Work Order ID 92812

Item Name: Window Frame

DRAWING NO.
D3290
TITLE
REPLACEMENT WINDOW ASSEMBLY
SCALE
1:5

DRAWING NO. D3290	TITLE REPLACEMENT WINDOW ASSEMBLY	REV. C	DART AEROSPACE LTD ENGINEERING ORDER		D.E.O. NO. D3290-C-1	SHEET NO. SHEET 1 OF 1	SCALE NTS
DRAWN 92	CHECKED 1	MFG. APPR. E	APPROVED W		DE APPR. H		
DATE 09.09.18	DATE 09.09.18	DATE 09.09.18	DATE 09/09/21		DATE 09/09/21

D3290-1 FRAME

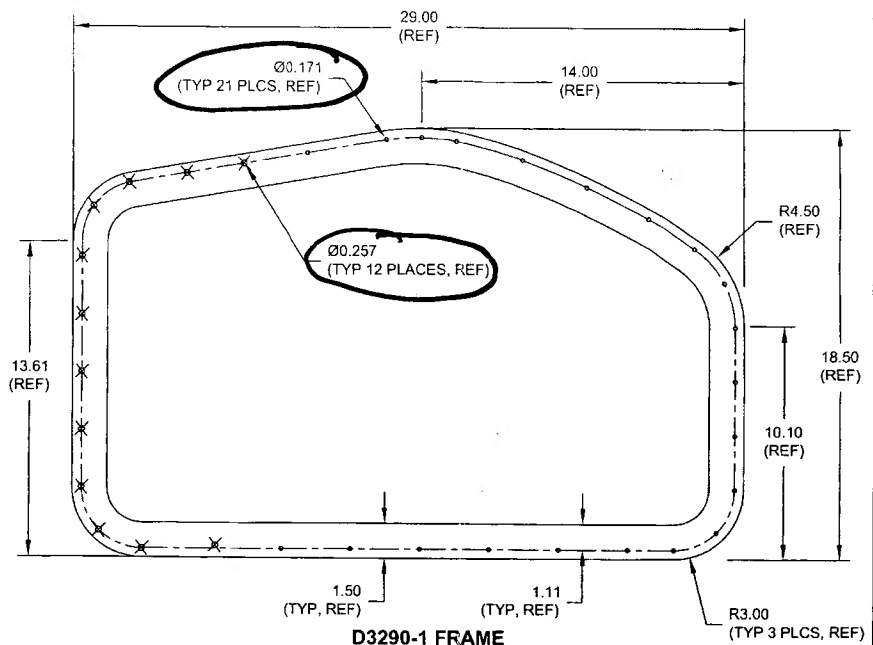
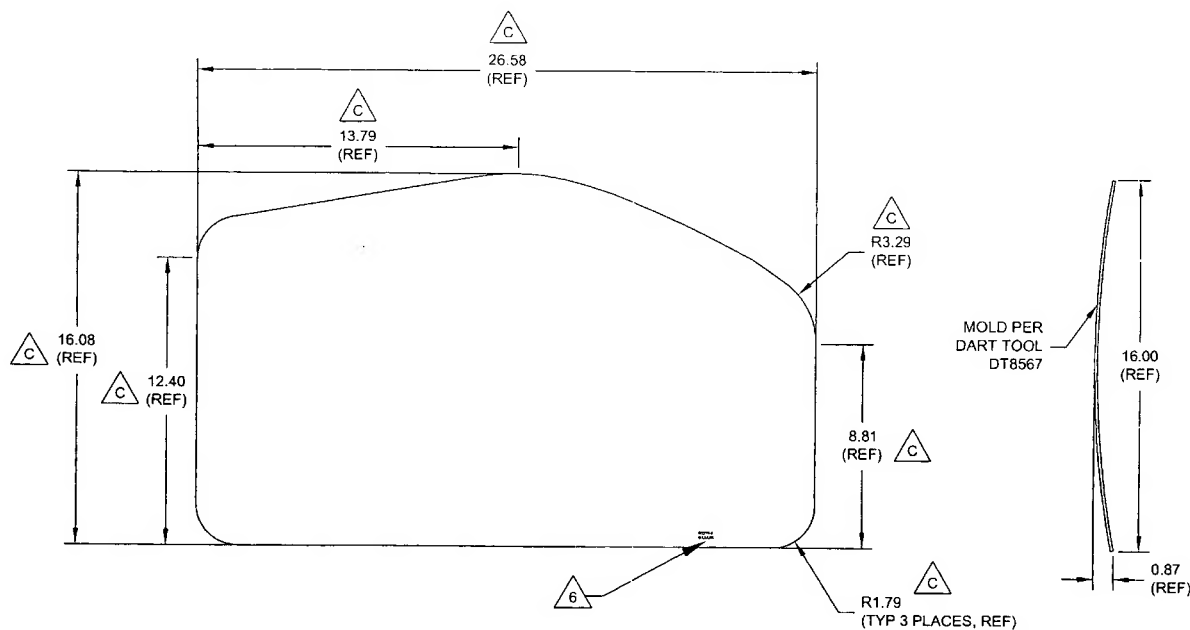
PURPOSE:

CHANGE MATERIAL THICKNESS OF D3290-1 FRAME TO 0.063 FROM 0.040. REF PAR 09-033. *W*

MATERIAL CALL-OUT OF D3290-1 FRAME ON SHEET 1 IS AMENDED AS FOLLOWS:

- 1) MATERIAL: 6061-T6 (OR 6061-T62) ALUMINUM SHEET ~~0.040 THICK~~ 0.063 THICK (REPLACE)
 PER AMS-QQ-A-250/11 OR AMS 4025 OR AMS 4027
~~(REF. DART SPEC. M6061T6S.040)~~ REF. DART SPEC. M6061T6S.063 (REPLACE)
 OR
 5052-H32 ALUMINUM SHEET ~~0.040 THICK~~ 0.063 THICK (REPLACE)
 PER AMS-QQ-A-250/8 OR AMS 4016
~~(REF. DART SPEC. M5052H32S.040)~~ REF. DART SPEC. M5052H32S.063 (REPLACE)
